Product Change Notification
Software Release Notice

MultiTech[®] Conduit[®]
Family of Programmable Gateways:
Conduit IoT Programmable Gateway
Conduit IP67 Base Station,
and Conduit AP Access Point

mPower[™] Edge Intelligence
mPower 5.2.X Firmware Available

Product Change Notification Number
PCN 05282020-001

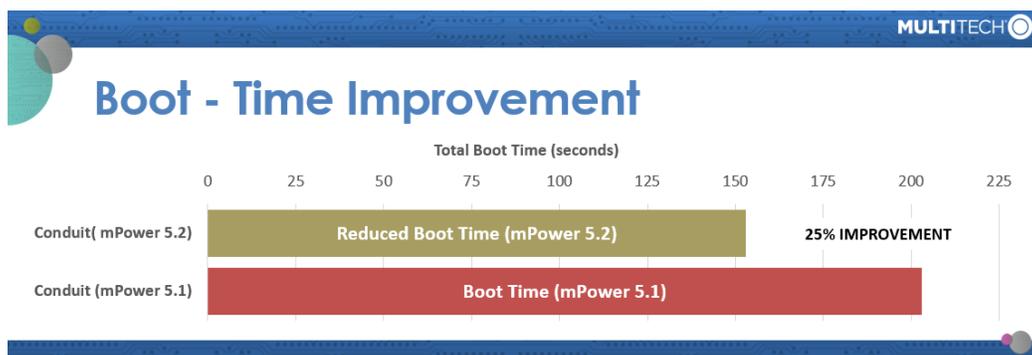
1. **Reduced Boot Time** Previous versions of mPower resulted in longer boot times. mPower 5.2.X includes new features and optimization that decrease the device boot time up to 25% [GP-256, GP-360, GP-362, GP-363, GP-364]

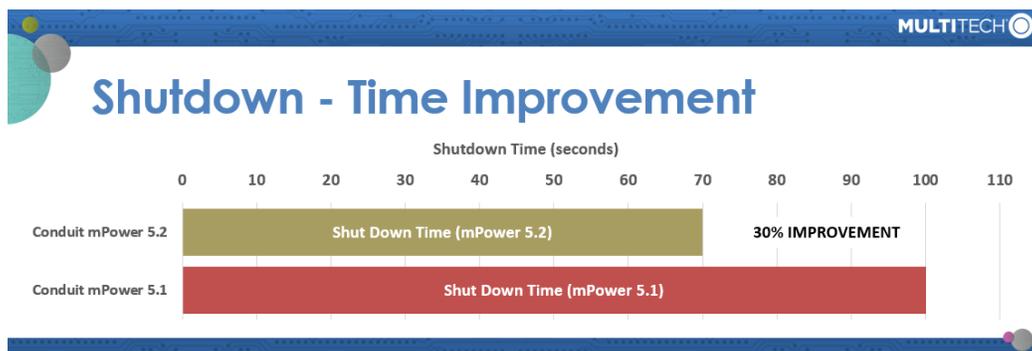
2. **Shutdown Time Optimization:** When restarting a device, the total time to reboot also includes shutdown time. Previous versions of mPower resulted in longer shutdown times. mPower 5.2.X has been updated to reduce shutdown time. Conduit mPower shutdown time has been shortened by 30%.

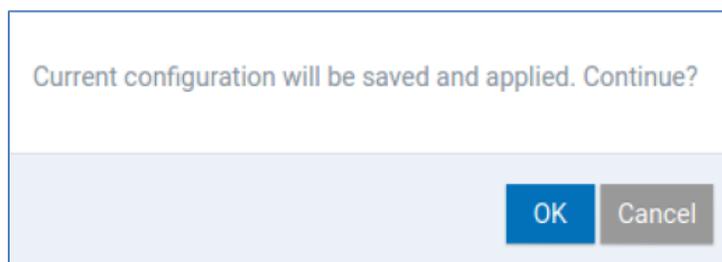
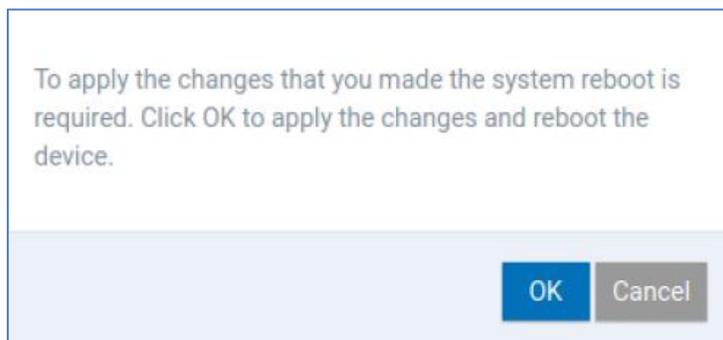
3. **Save and Apply Configuration Settings without Restarting:** Previous versions of mPower required a device reboot for most system configuration settings. mPower 5.2.X has been updated to save and apply many configuration settings without the need to restart. In these cases, the user will be presented a “Save and Apply” button after making configuration settings. If “Cancel” is selected, changes are not saved. [GP-339]

A limited number of system configuration setting changes will still require the device to be restarted. In these cases, the user will be presented with a “Save and Reboot” button after making configuration settings. If “Cancel” is selected, changes are not saved.
